Land at Gosford

Technical Note 11: Response to Oxfordshire County Council (OCC)

22nd June 2023

| Appendix B - Site Access Drawing

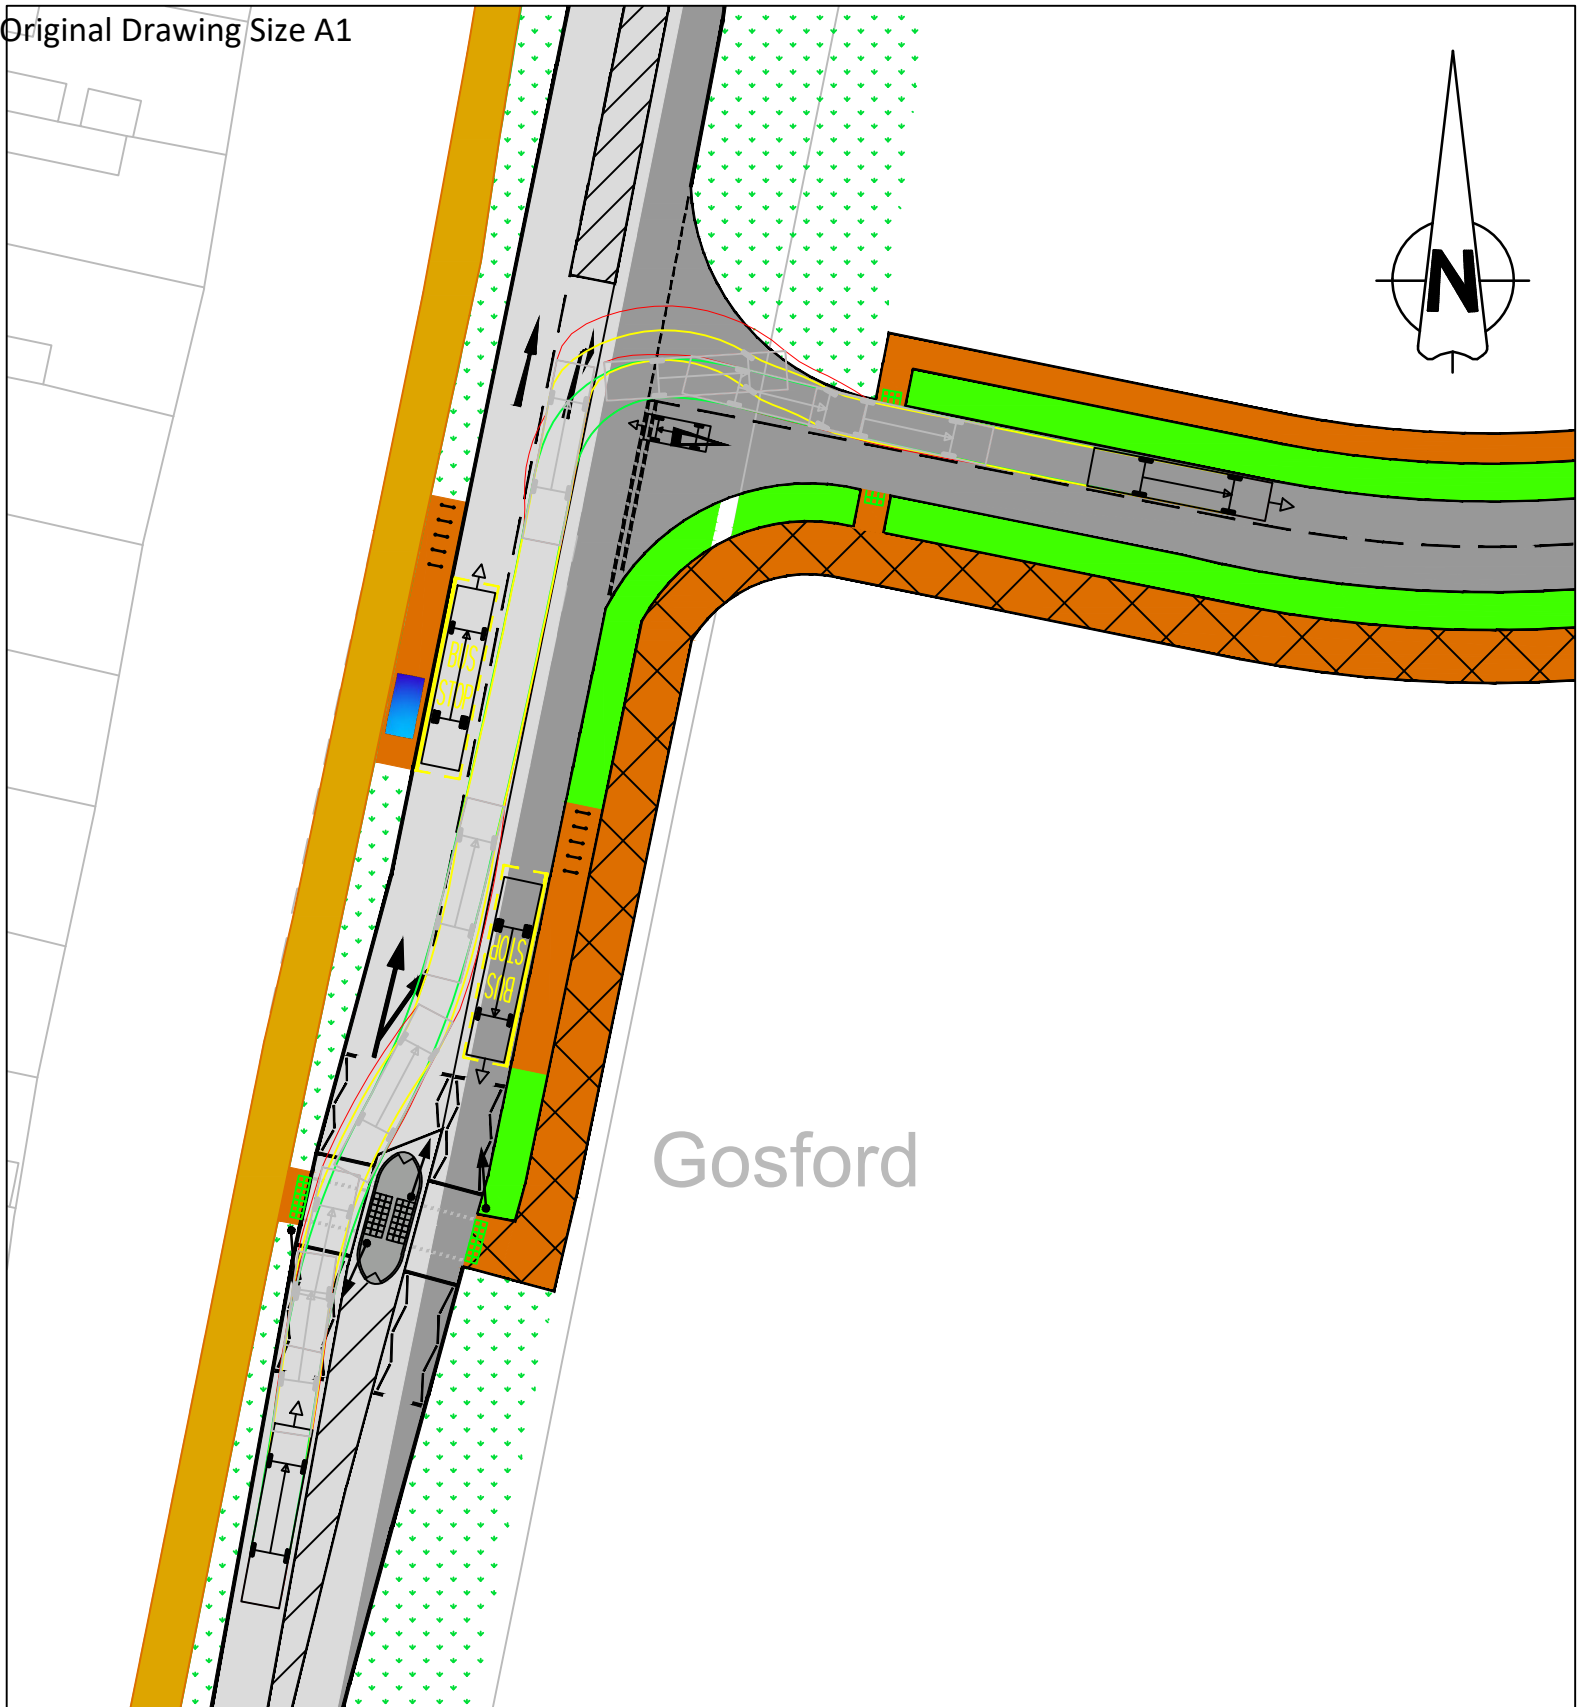
OCC Comment: Vehicular Access – Bicester Road runs along the western frontage of the site and so, several accesses shall be taken off it. The principal vehicular access for the entire PR7a allocation is proposed via a T junction ghost right turn off Bicester Road as shown by Drawing no. 10669-SK-05 Rev A. The vicinity of the site access along Bicester Road is fairly straight. The proposed access thereby benefits from adequate visibility splays although the splays need to be indicated on the access plan. Although not part of this submission, a second point of access into the parcel of land controlled by Hill shall be taken from a simple T junction off Bicester Road north of the cemetery which shall be delivered via a second planning application.

OCC Comment: The application proposes a number of pedestrian and cyclist access points to adjoining lands – this is welcomed. Along Bicester Road frontage, the application suggests up to two access points – via the principal site access and also utilising the downscaled existing site access. Both of these access

points are presenting unacceptable forms of provision that fail to meet guidance stipulated by LTN1/20. These are:

1. *Uncontrolled crossing on a busy 40mph Bicester Road is not acceptable. Such a crossing does not meet guidance of The Design of Pedestrian Crossings LTN2/95*
2. *Where existing access is being downgraded to pedestrian, the kerb line must be reinstated and instead dropped kerb type of access provided.*
3. *The type and design of crossing shown in the snippet below is unacceptable. It is not clear why the crossing has been staggered here. A suitable crossing that meets the needs of users and commensurate to the road speeds must be provided at this point.*
4. *We would suggest it is realigned to be straight.*

- 3.4** This is noted and the drawings has been amended to include the appropriate visibility splays. The revised drawing is contained in **Appendix B**.

- 3.7** Paragraph 10.4.5 of LTN 1/20 refers to Table 10-2, which suggests the type of crossing that is appropriate and continues to confirm that it is a guide only, and individual locations should be assessed on a case-by-case basis. It is important to note that the development will deliver a network of walking / cycling routes and does not rely on any single crossing point. The most dominant desire line is towards the south, trips in this direction can be achieved via the sustainable link across Bicester Road, or alternatively pedestrians and cyclists can travel through the development to exit at the southern access point adjacent to the existing signalised crossing. However, taking on board the observations raised by OCC the uncontrolled crossing on Bicester Road is to be replaced with a signalised crossing point with the stagger removed. The revised crossing layout is included within the site access arrangements and is shown within **Appendix B**.
